STAFF REPORT FOR THE HISTORIC REVIEW BOARD

FILE NUMBER: MISC-17-11

REQUEST: Amendment/new structure of an initial application DR-17-06 in the Historic District

SUBJECT: MISC-17-11 Major amendment/new structure amending an initial application DR-17-06 that approved a front porch and rear addition to an existing, noncontributing home in the Historic District at 1744 4th Ave.

Changes proposed by MISC-17-11 in Red of South elevation

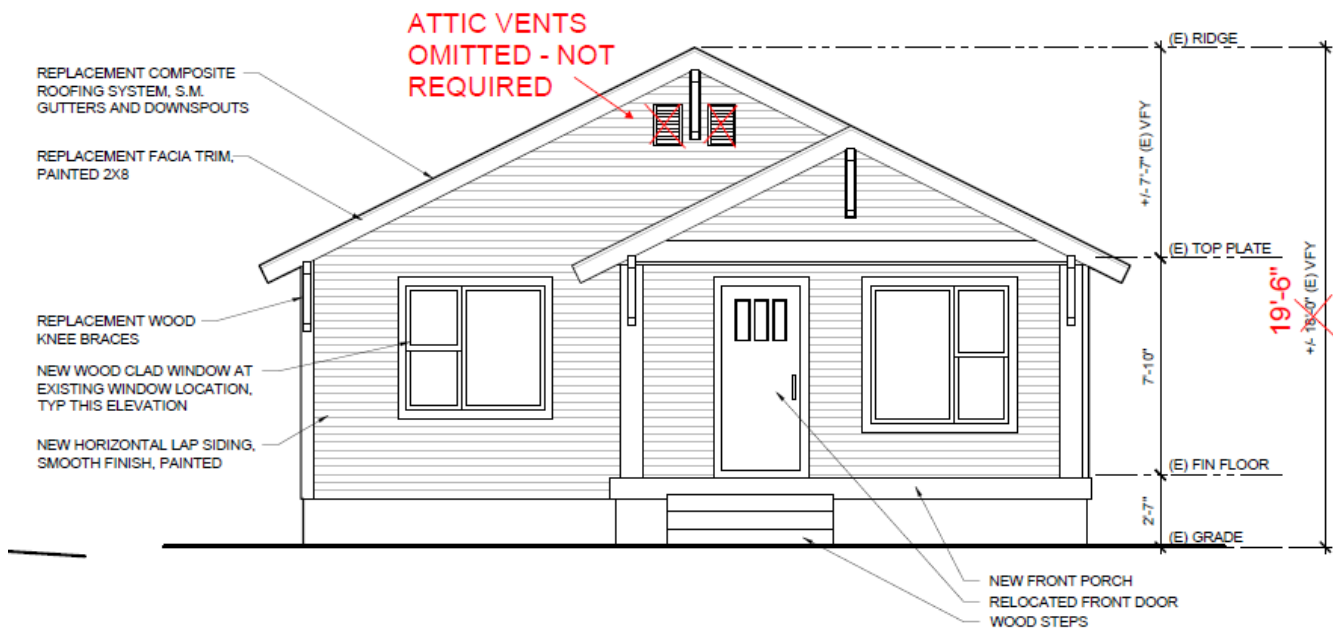
After construction began on the approved addition and front porch the original structural supports were exposed to reveal severe decay. In order to install new truss supports for the new roof, the original roof was removed. Once removed the original walls collapsed and original material was removed from the site. An additional change by the applicant requests an increase in the roof height 18 inches with no change to the roof pitch.

Project Description: An amendment is requested to address changes to the original approval: the removal of existing exterior walls, replacement without matching historic material, and increasing the height of the roof 18 inches. After construction began on the approved addition and front porch the original structural supports were exposed to reveal severe decay. The original walls of the structure collapsed and then were rebuilt. In addition, the applicant also requests an increase in the roof height 18 inches with no change to the roof pitch.

A3.10

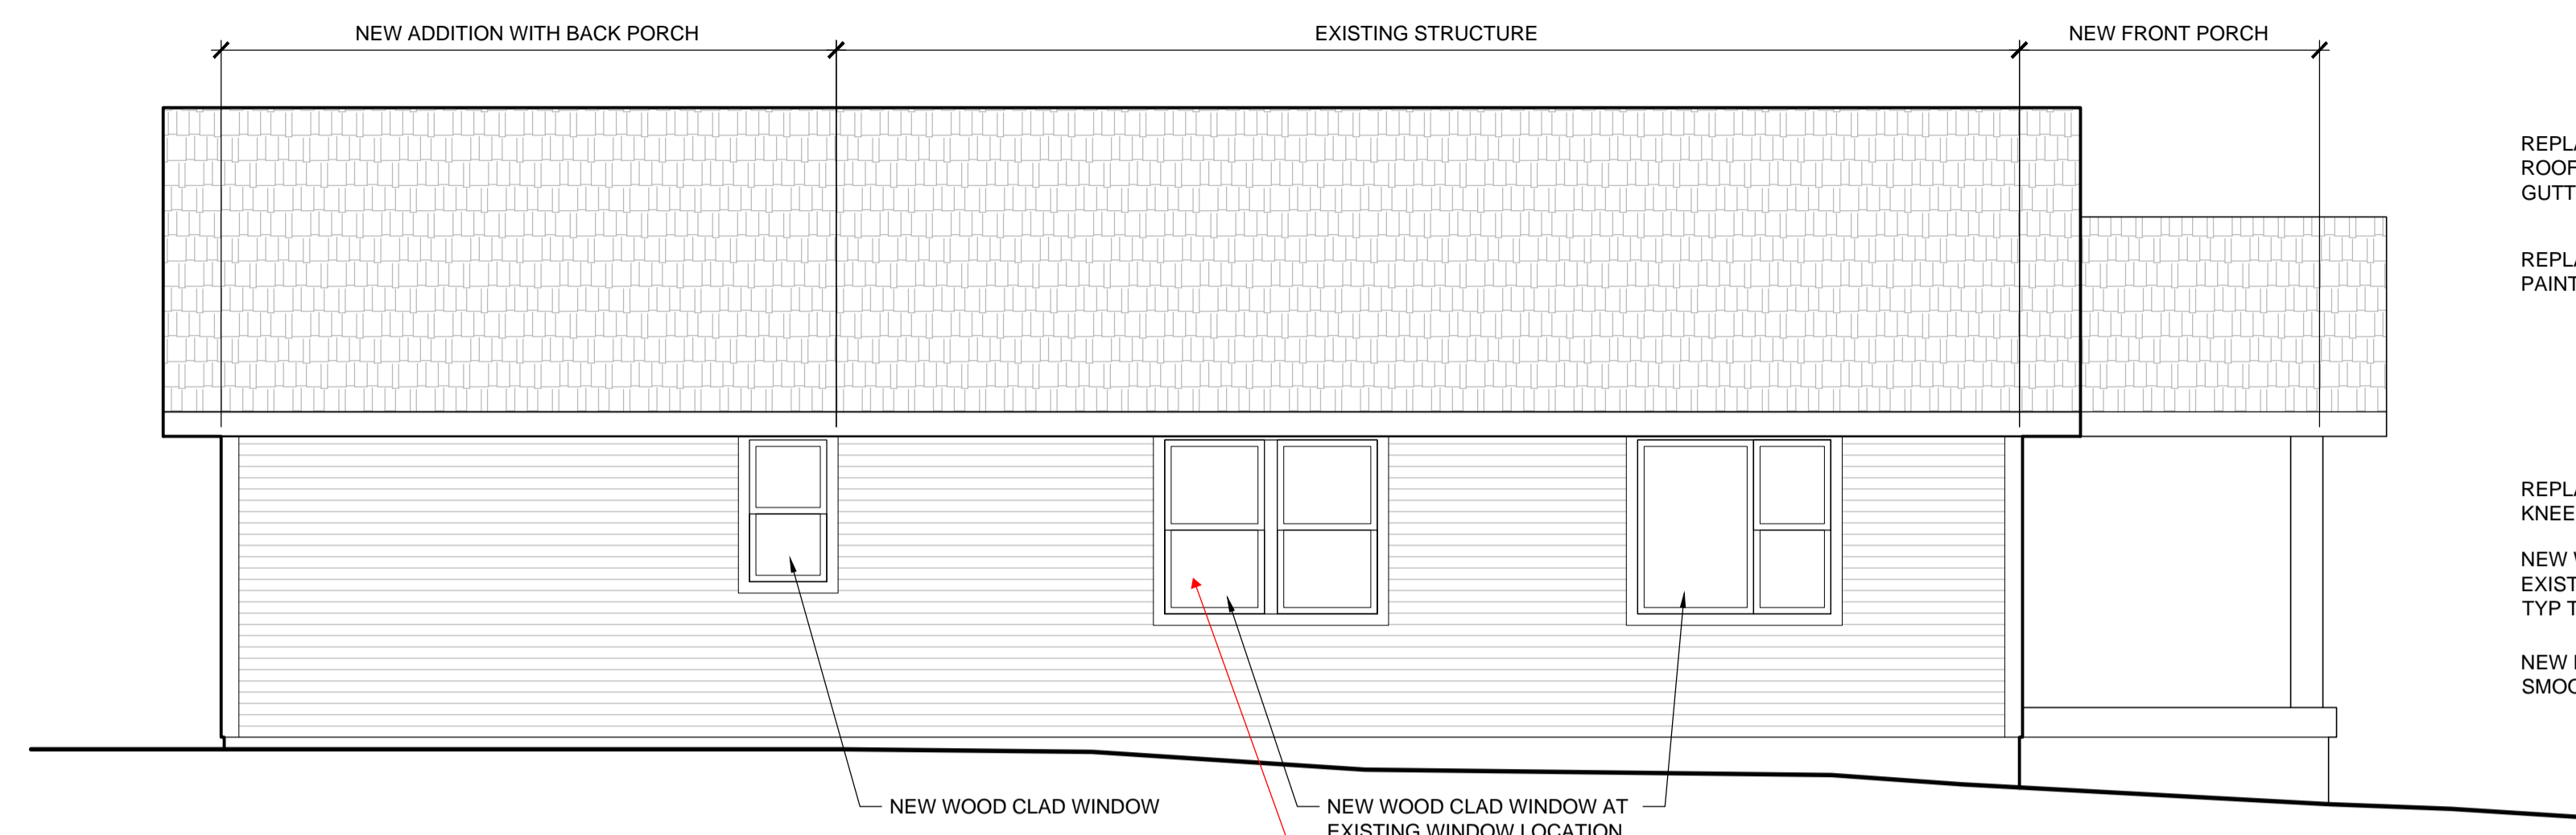
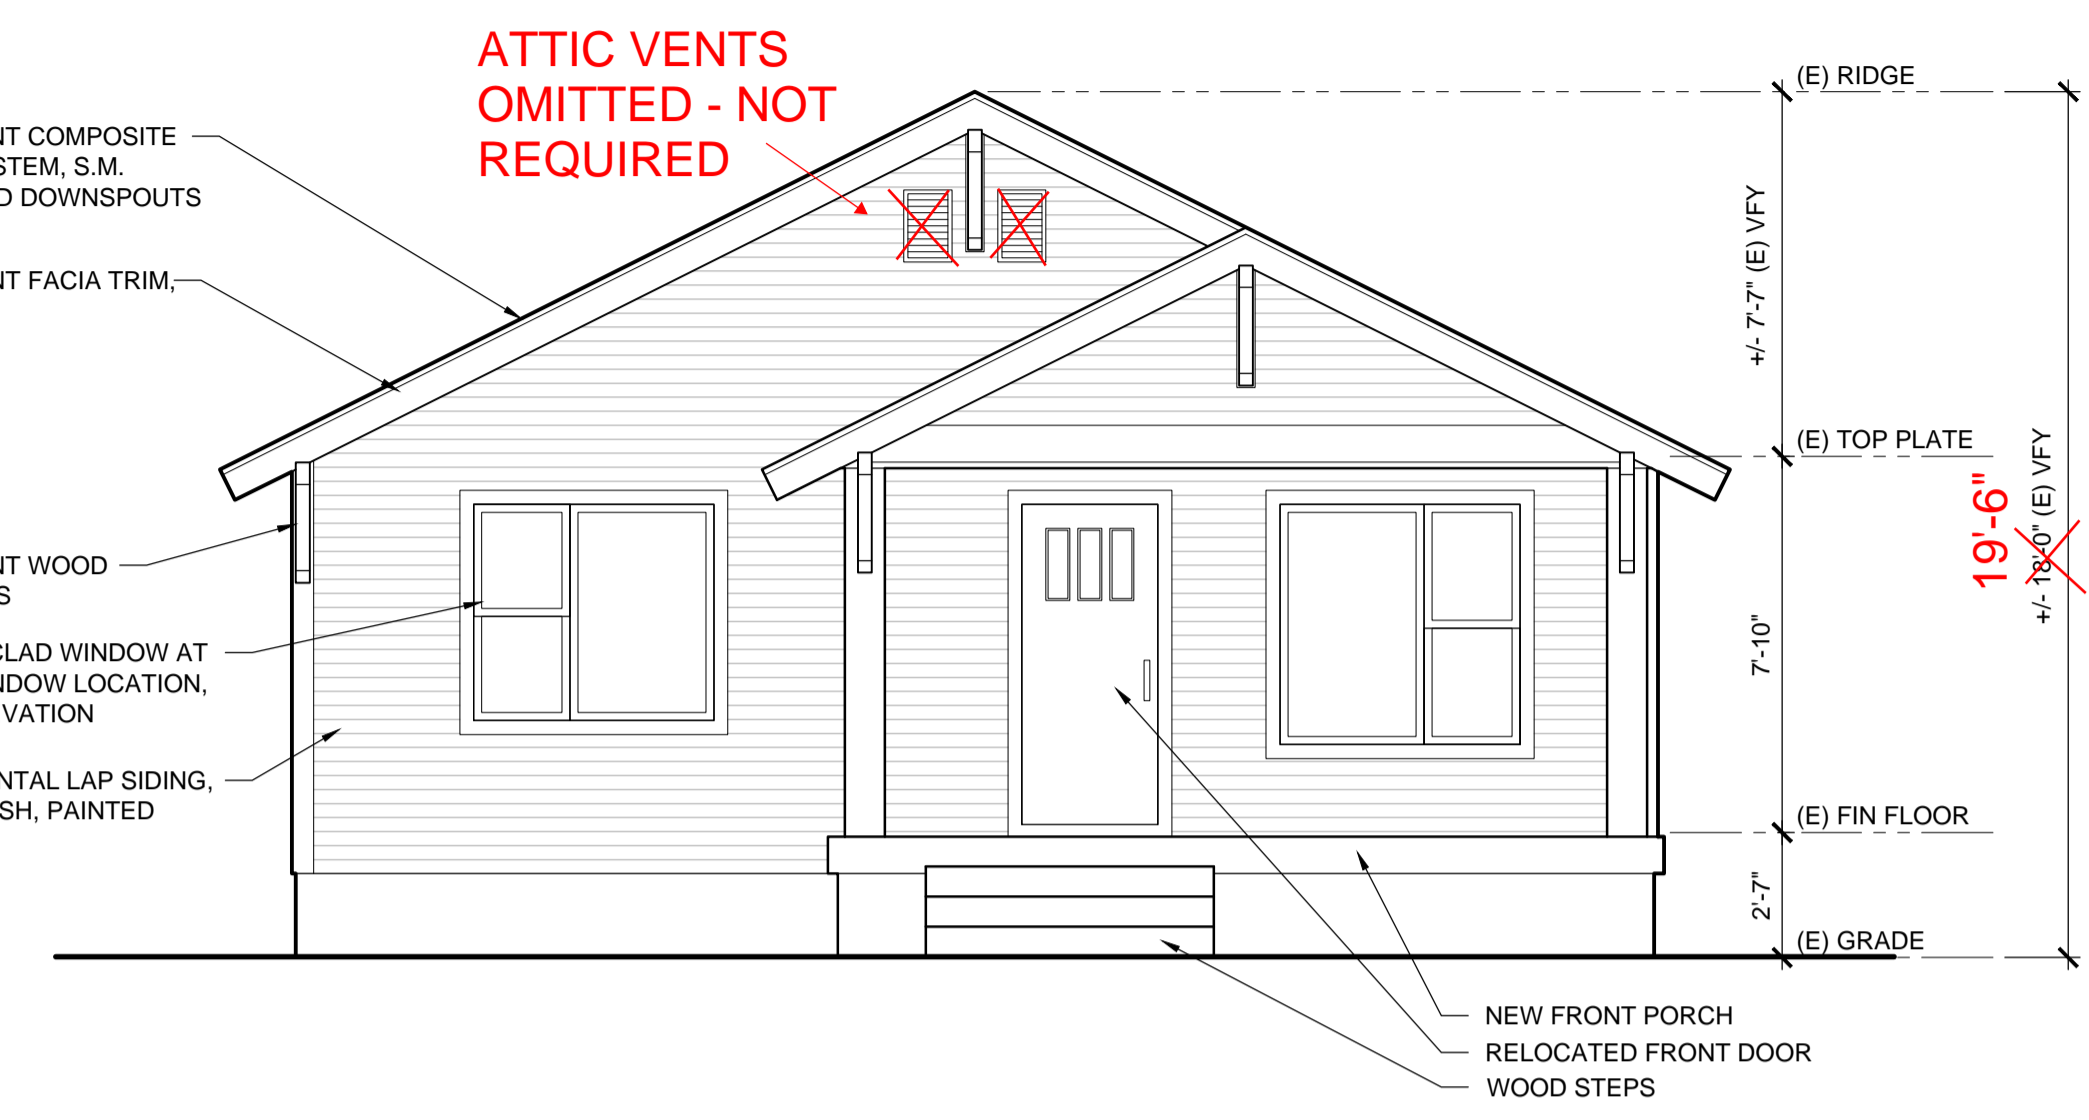
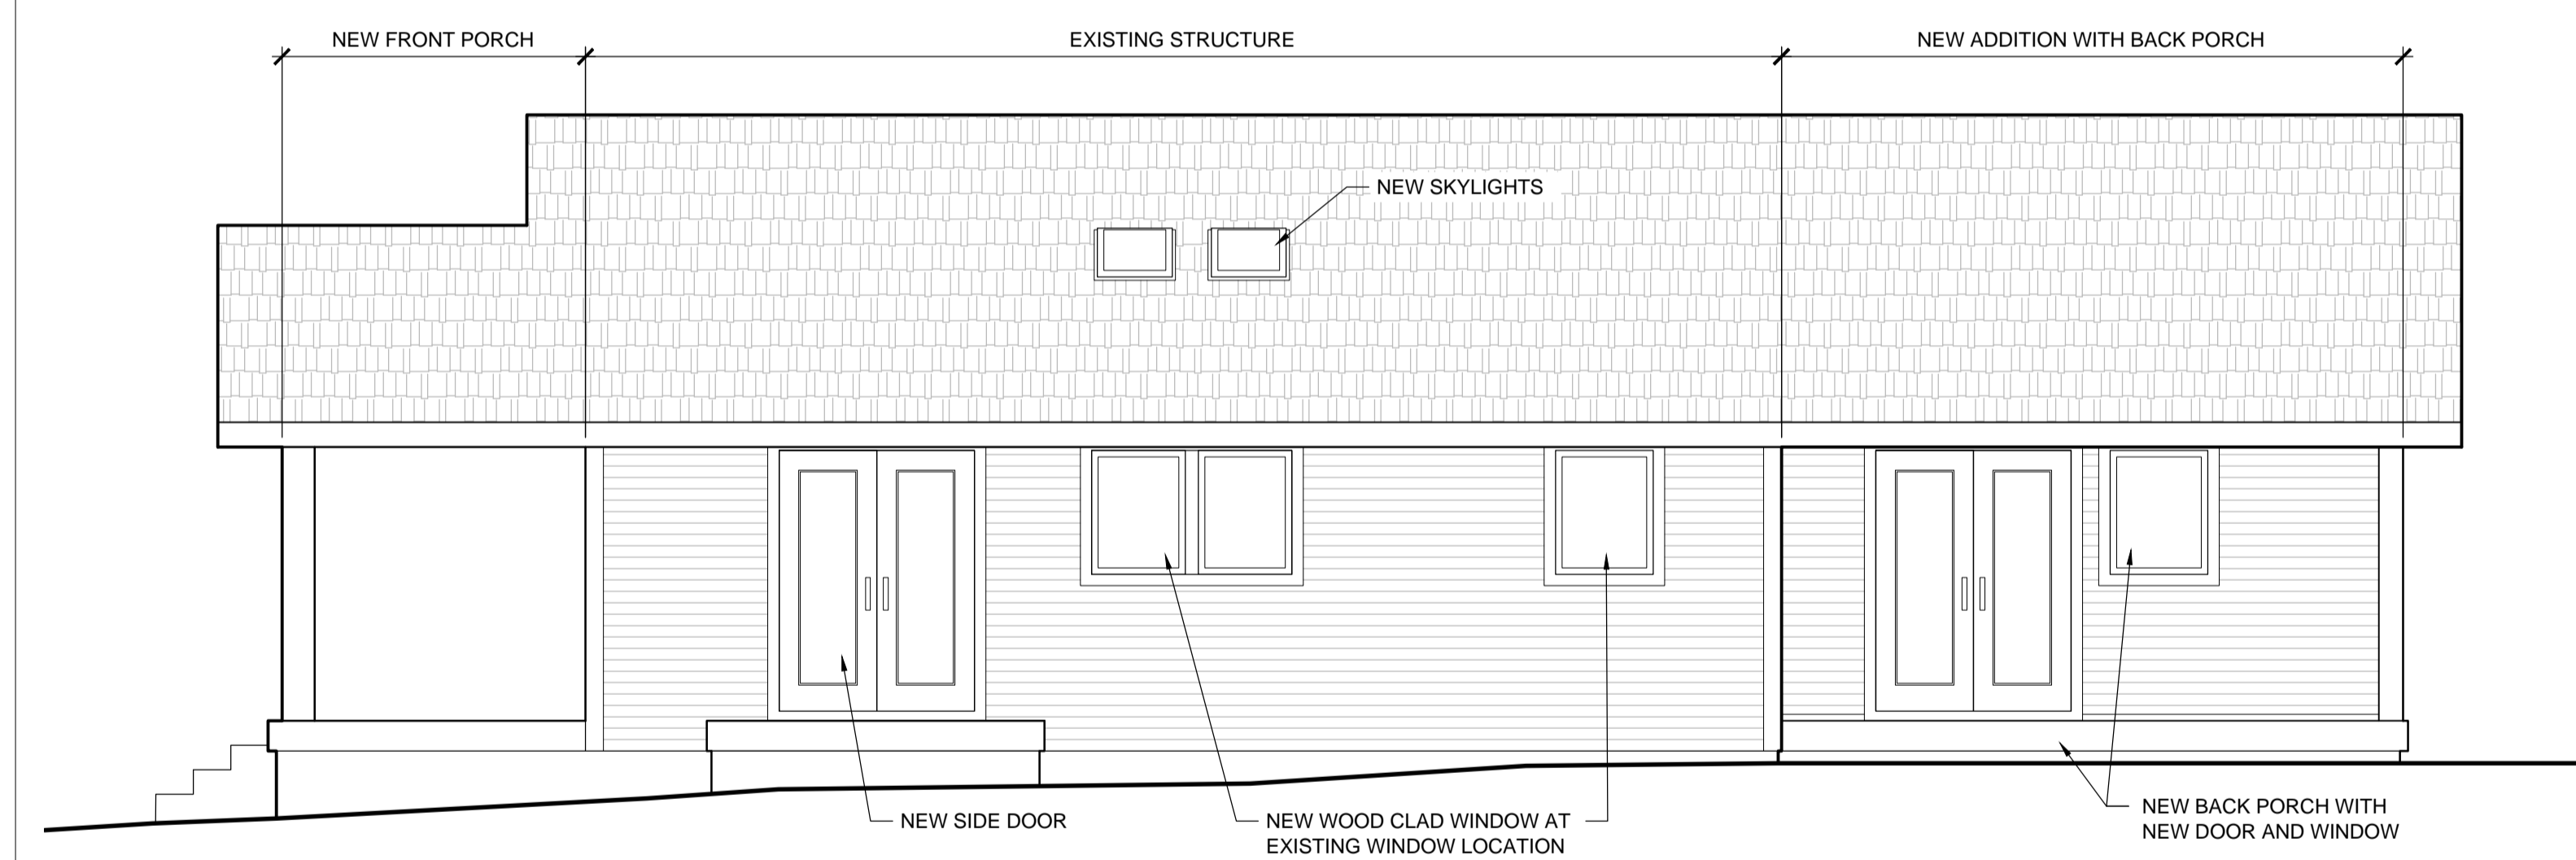
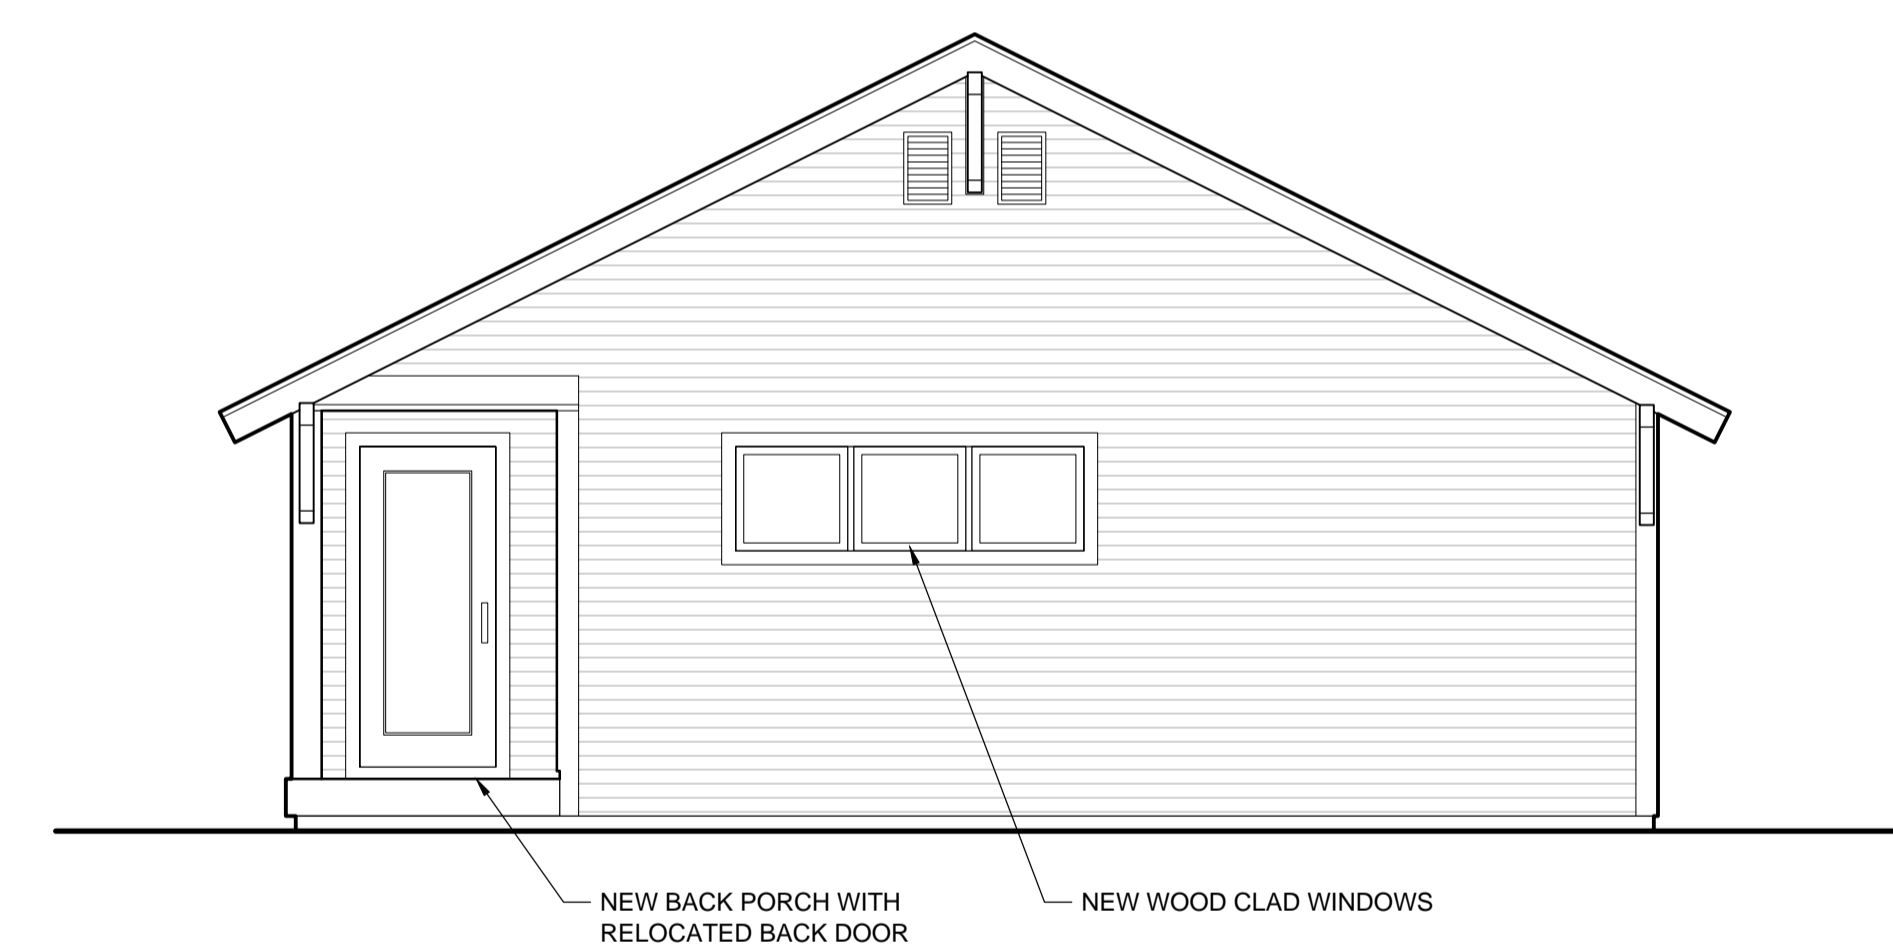
Staff Finding 7: The roof line of the home is proposed to be increased 18 inches, but maintain the same pitch (see page 3 of the applicant's narrative). The roofline will be maintained through the rear addition (see sheet A3.10). Subject to the review and approval of the HRB for the requested amendments, the criteria would be met.
